Private Fuel Storage, L.L.C.

January 25, 2001

RISK ASSESSMENT OF ACCIDENTS INVOLVING CRUISE MISSILES
DOCKET NO. 72-22/TAC NO. L22462
PRIVATE FUEL STORAGE FACILITY
PRIVATE FUEL STORAGE L.L.C.

RISK ASSESSMENT
OF
CRUISE MISSILE ACCIDENTS
IMPACTING
PRIVATE FUEL STORAGE LLC
INDEPENDENT SPENT FUEL
STORAGE INSTALLATION

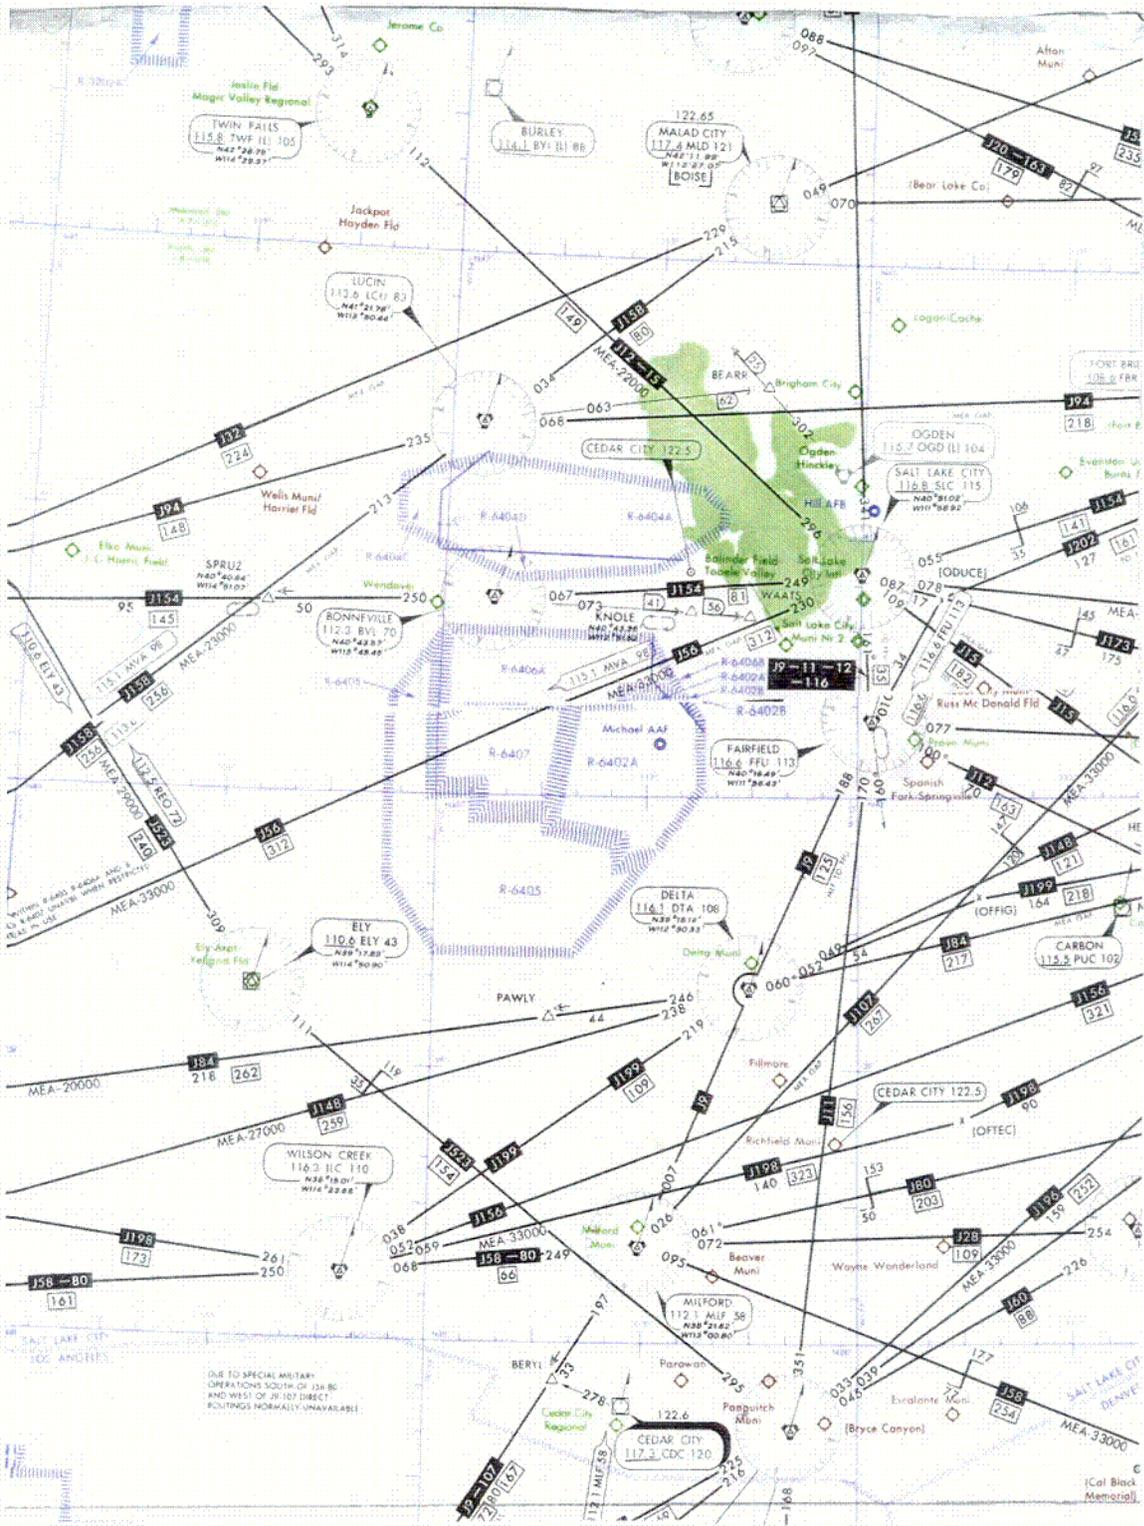
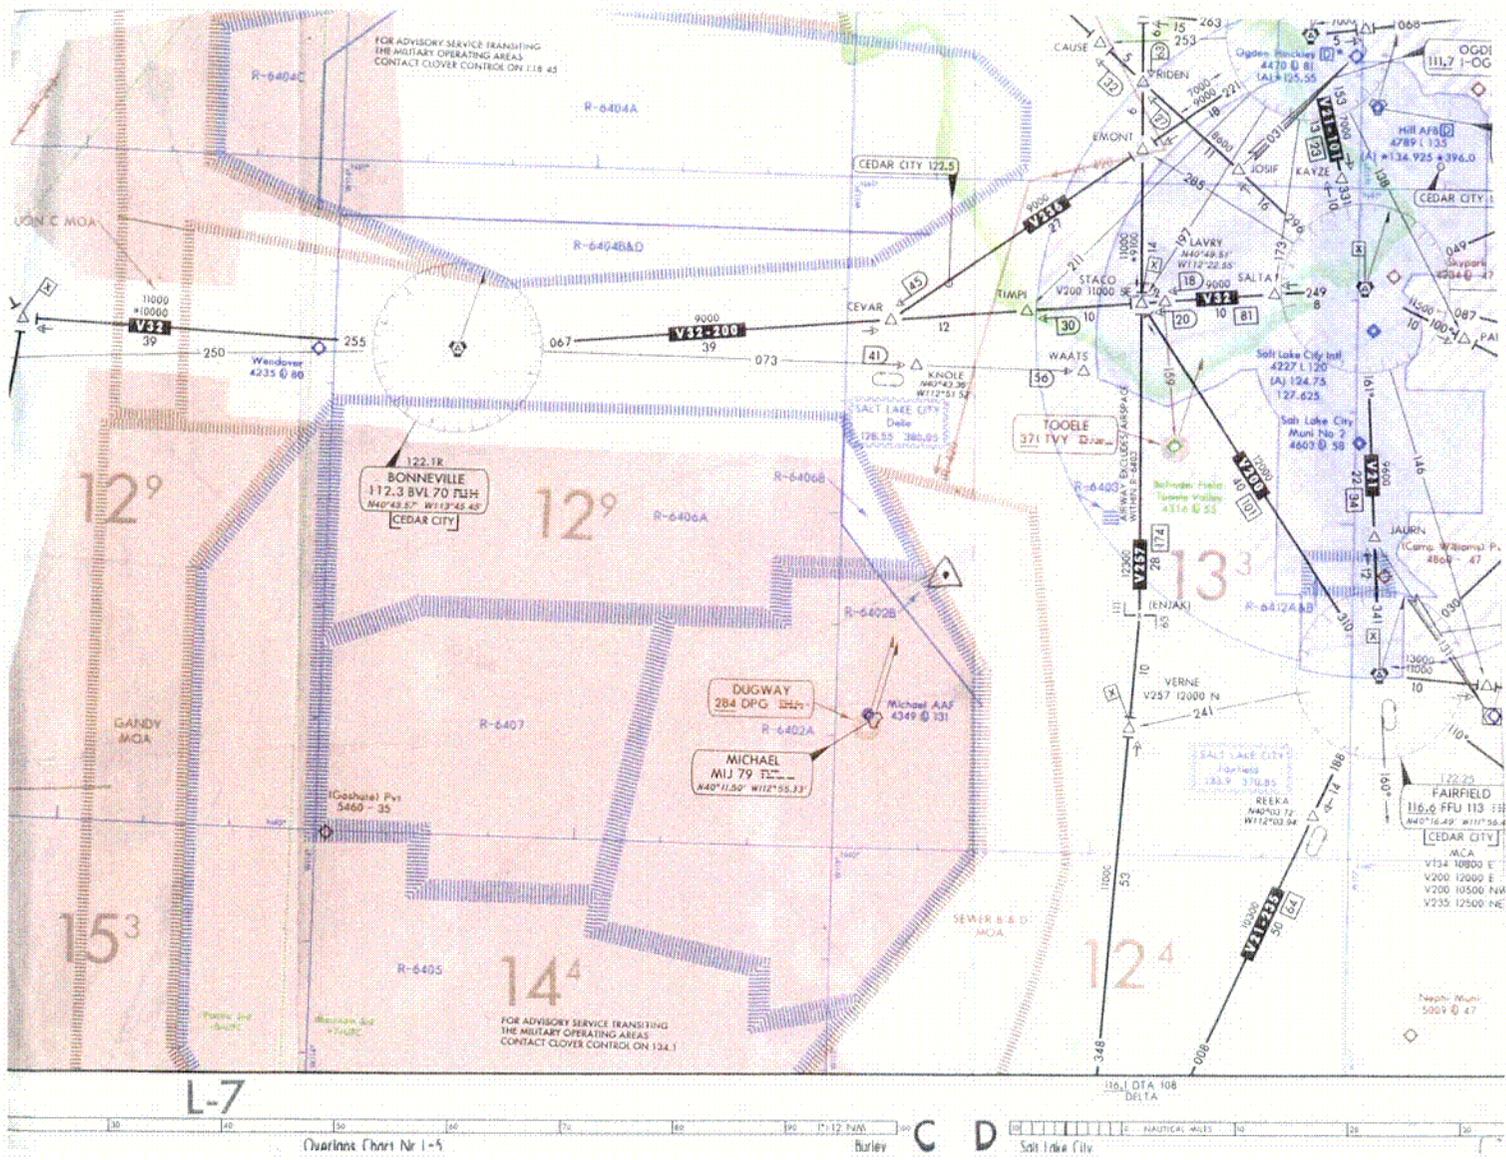
Figures 7, 8 and 9 to the Report (Revision 0) are difficult to read.

The color prints probably lost quality in the copying process and we are providing original color prints of these Figures to both the Staff and the Center.

Figure 9: Military Low-Level Route Structure Associated with UTTR

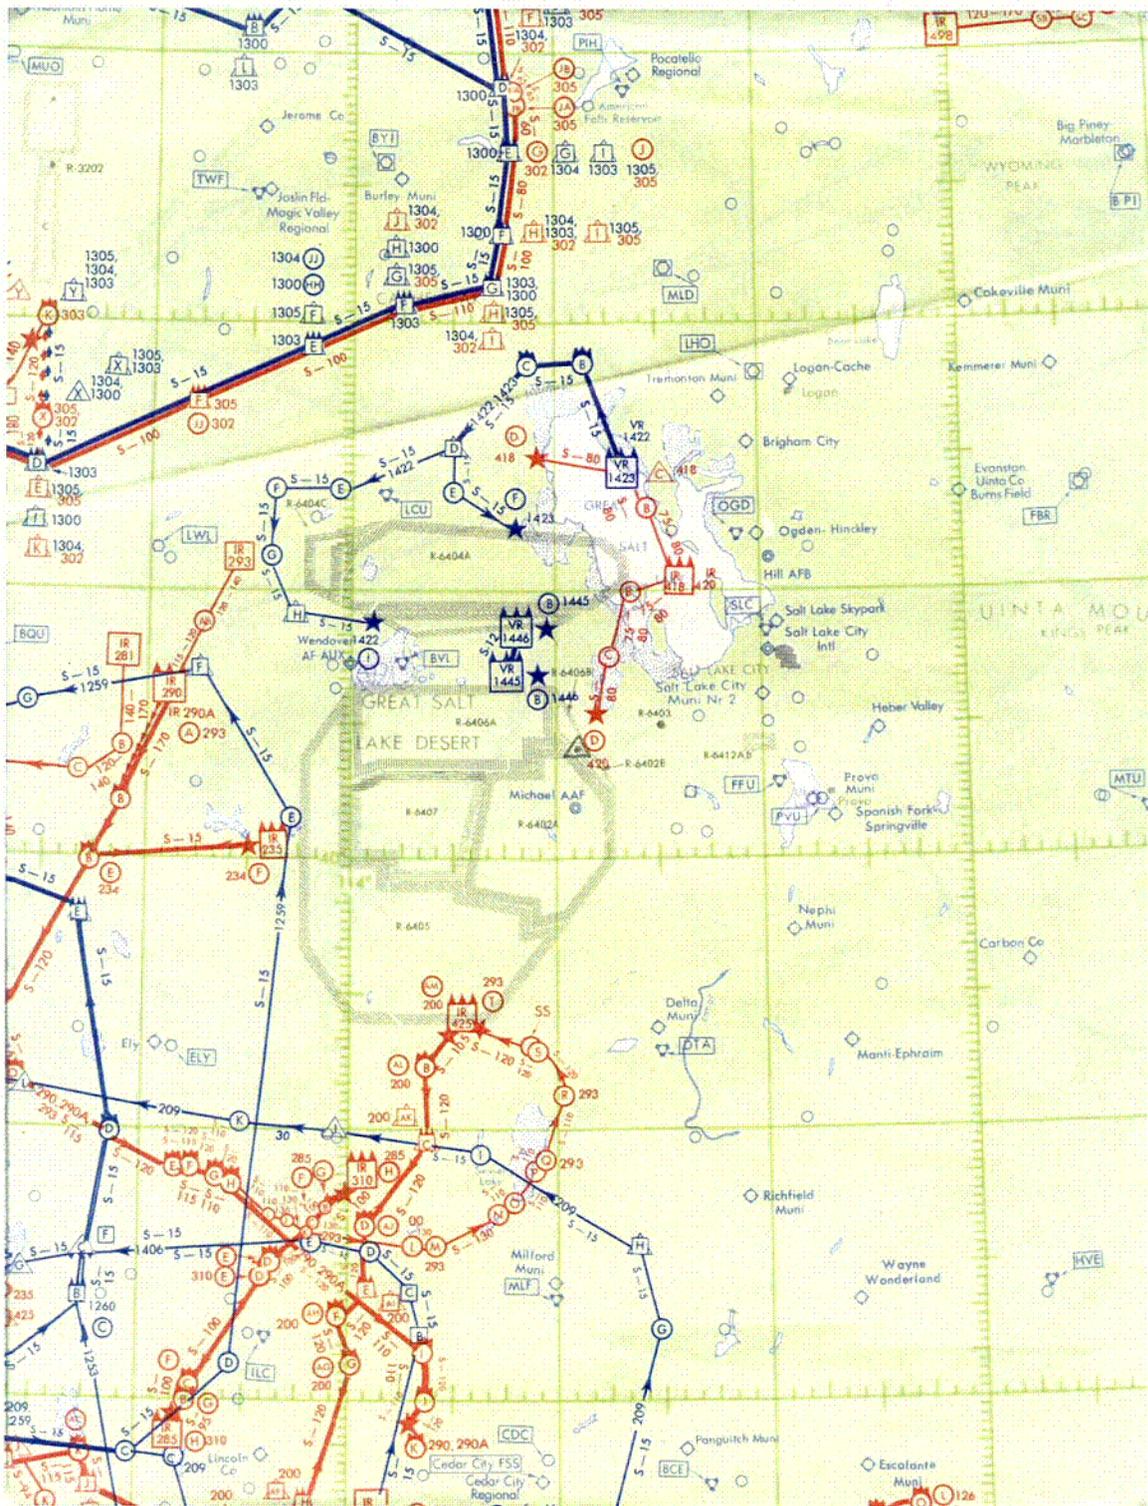
Figure 9 in the Report (Revision 0) is described as "the military low-level route structure associated with UTTR" on page 12, but on page 15 it is labeled as "FLIP Military Route Planning Chart." Are both of these correct?

Both are correct; FLIP is an acronym for Department of Defense "Flight Information Publication." The title to Figure 9 in the enclosed Report (p. 15) has been revised to clarify that it reflects the "Military Low-Level Route Structure Associated with UTTR."

Figure 15: South Range Cruise Missile Routing

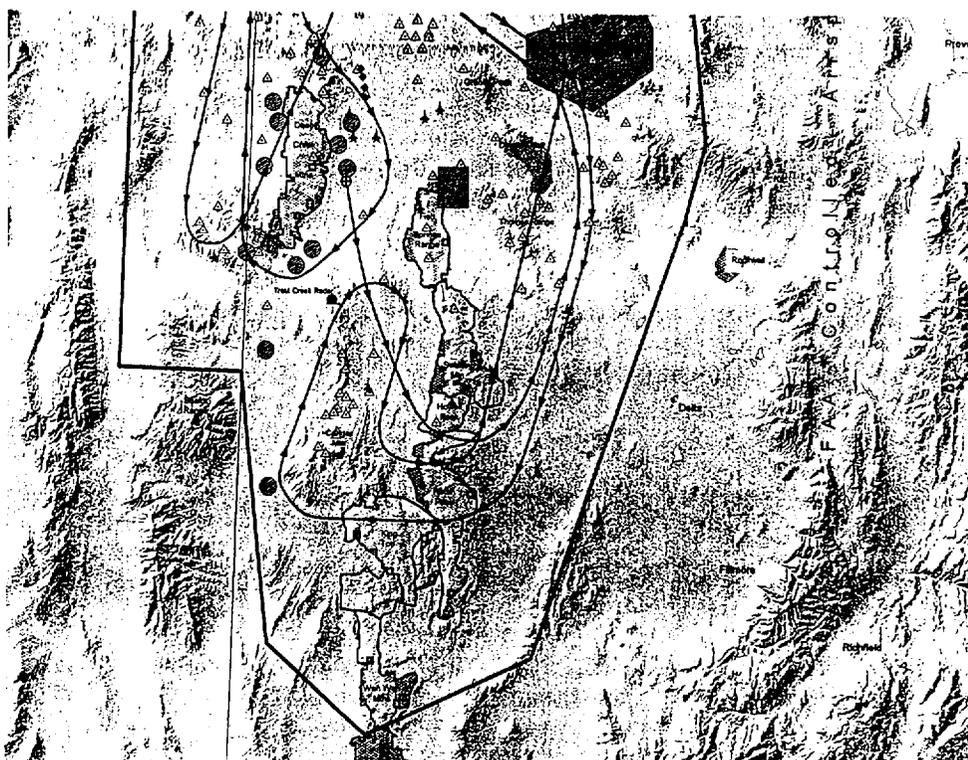
On page 36 of the Report (Revision 0), it says that "Cruise missile trajectories are tangential (as opposed to radial) to the PFSF, with a point of approach no closer than 10 nm [nautical miles] from the facility," but Figure 15 on page 27 shows a route that is radial to the PFSF at various points. How do you reconcile those two things?

This sentence in the enclosed Report (p. 36) has been revised to clarify that "[a]t their closest point of approach to the PFSF, cruise missile flight trajectories are tangential (as opposed to radial) to the PFSF, coming no closer than 10 nm [nautical miles] from the facility." The points on the route shown in Figure 15 at which the trajectory is radial to the PFSF are to the south and west of Michael Army Airfield, more than 15 nautical miles from the PFSF and well beyond the downrange distance that a cruise missile would travel upon activation of the FTS system.

Figure 16A: Downrange Distance Graph After FTS Termination (From Boeing Tech Order Data)

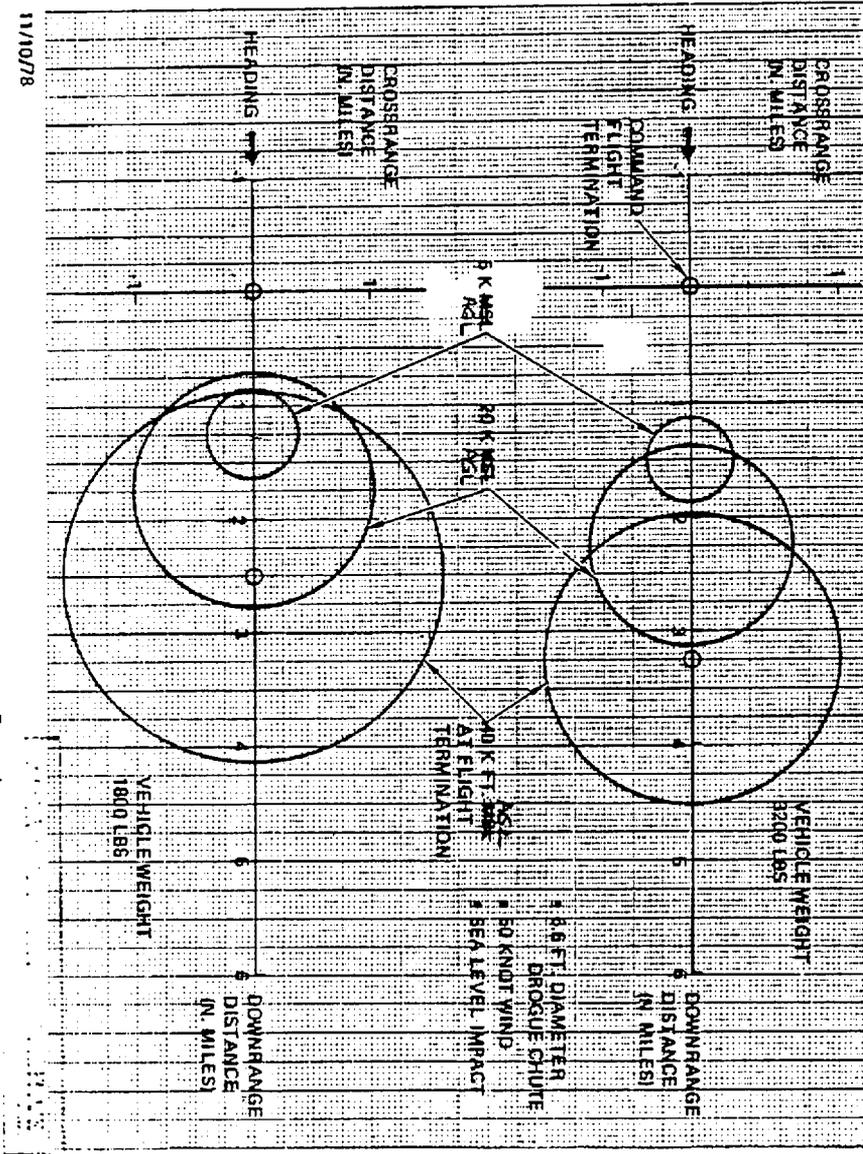
A 50-knot wind is assumed in Figure 16A of Revision 0 of the Report (p. 33). Is a wind assumed in Figure 16B? The figure itself says it does not assume a wind.

Exhibit 4 to the Declaration of George Wagner and David Girman filed in support of Applicant's Motion for Summary Disposition of Utah Contention K, December 30, 2000, is a one page summary of "Flight Termination Footprints" for the ALCM with Figure 3.1-4 illustrating the impact footprints of the air vehicle and drogue chute for the two extremes of vehicle weight, launch weight and empty weight. Figure 3.1-3 referenced in the summary was provided as Exhibit 16-B to the Report. Why are the other figures referenced in the summary not provided?

The enclosed Report (p. 33) has been revised to clarify that only the distances in Figure 16 A (which depict the impact footprints for the two extremes of vehicle weight, launch weight and empty weight) conservatively assume a 50-knot wind blowing in the most disadvantageous direction. Figure 16 B (which only depicts trajectory profile and not impact footprints) does not include wind.

Figure 3.1-4 attached as Exhibit 4 to the Wagner/Girman declaration is the same as Figure 16A in the Report. It was attached separately to the Wagner/Girman declaration to draw attention to the figure, since it contains the significant information on impact distances from point of activation of the FTS for both vehicle launch weight and empty weight. Figure 3.1-3 referenced in the one page summary that was included as part of Exhibit 4 to the Wagner/Girman declaration was also provided in the Report as Figure 16B to illustrate typical trajectory profiles. Our experts did not obtain all of the other figures referenced in the summary from the Air Force and they are not necessary for the understanding of the missile impact footprint distances depicted on Figure 3.1-4 (which are bounding for the ALCM), and as such are not referenced or included in the Report. In particular, the FTS compartment cover discussed in the summary weighs less than 10 pounds, and thus poses no threat to the PFSF.
